NO. 78 (LOT 153) GILBERTSON ROAD, KARDINYA

AMENDMENT TO DEVELOPMENT APPROVAL – FORM 2 (DAP/21/02099)

APPROVED DEVELOPMENT

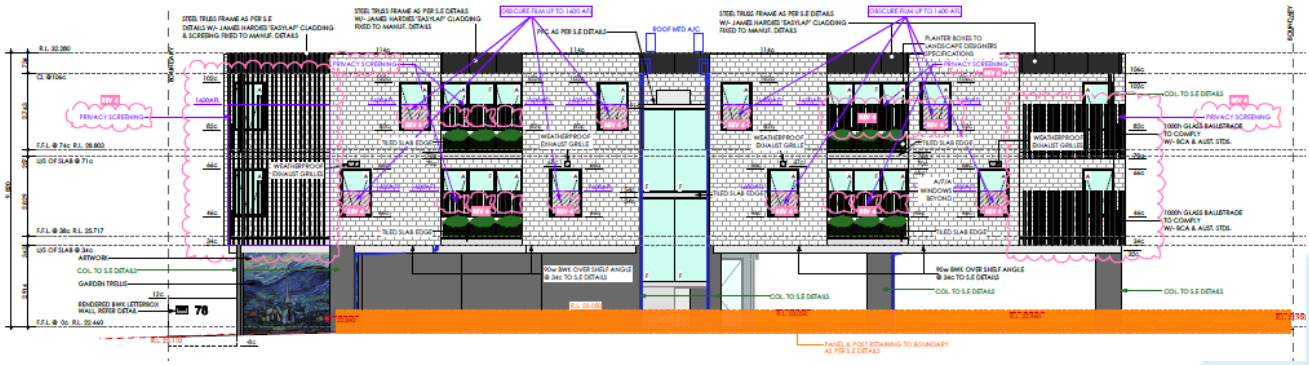
The approved development incorporates breezeblock screening, gold coloured screening, balcony balustrades and planter boxes as prominent architectural elements across the upper levels of the building. These treatments contribute both to the visual privacy of adjoining properties and to the external architectural style of the development. The approved elevations demonstrate the use of breezeblock treatment across all four elevations.

The amended plans substantially revise the approved façade treatments, with breezeblock and gold-coloured screening largely removed and replaced by face brickwork and cladding, glass balustrading, powder-coated aluminium privacy screening and obscure glazing/tinting. The planter boxes to the northern and southern balconies are retained. The images below illustrate the extent of these changes to the northern elevation.

MODIFIED DEVELOPMENT

E4 NORTH ELEVATION
1:100

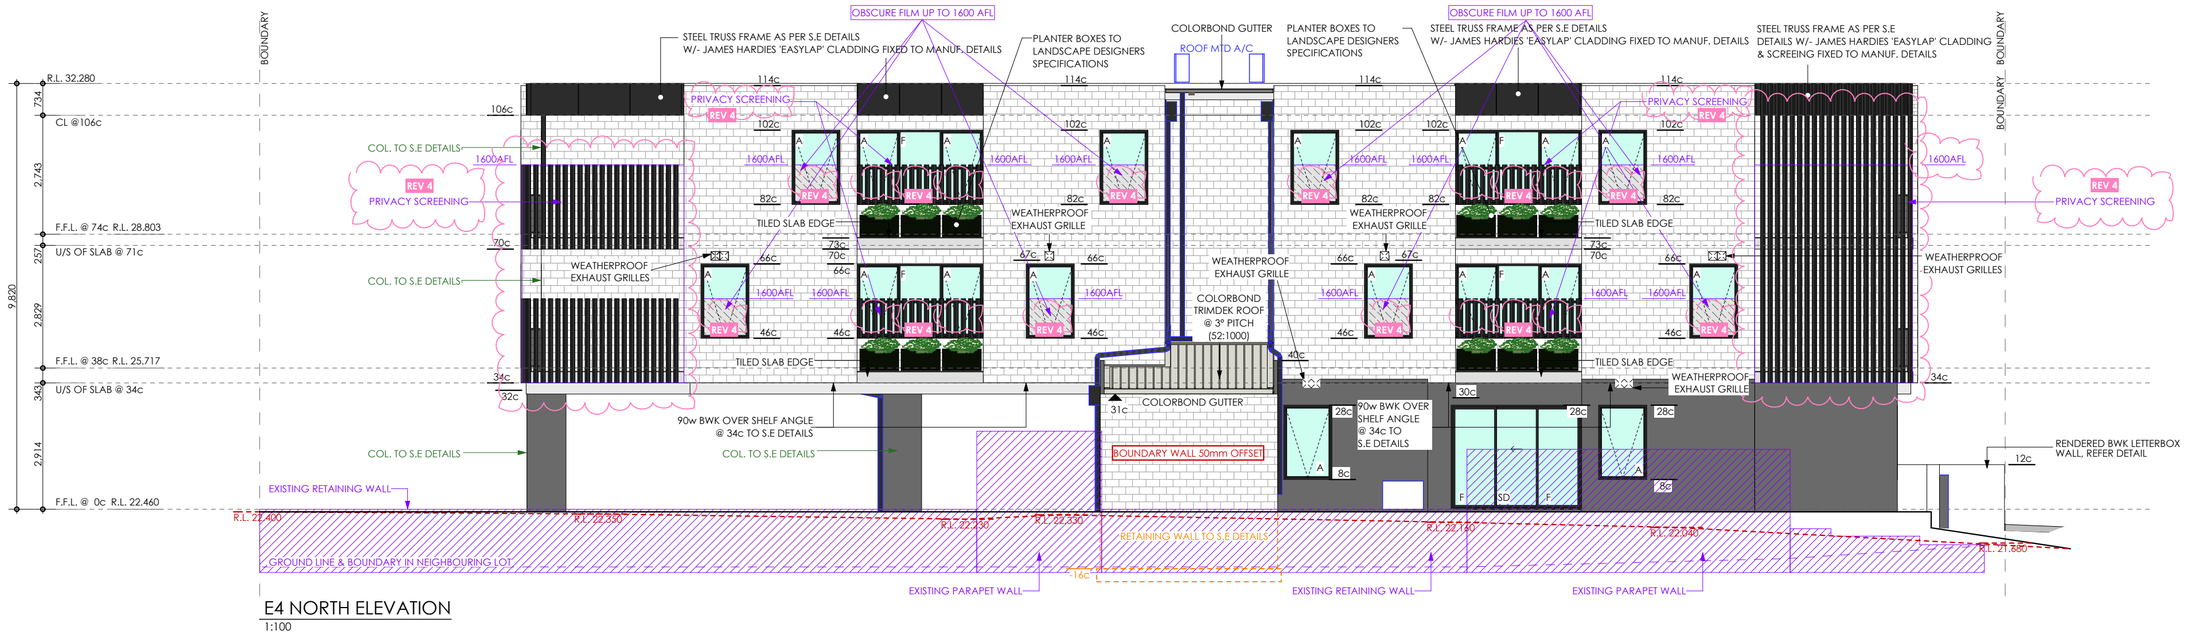
- Obscure glazing/tinting extending to 1.6 metres above finished floor level to selected windows, particularly along the northern and southern elevations.
- Landscaped planter boxes and visual privacy screening to 1.6m.
- Glass balustrading to balcony areas where additional privacy screening is not required.
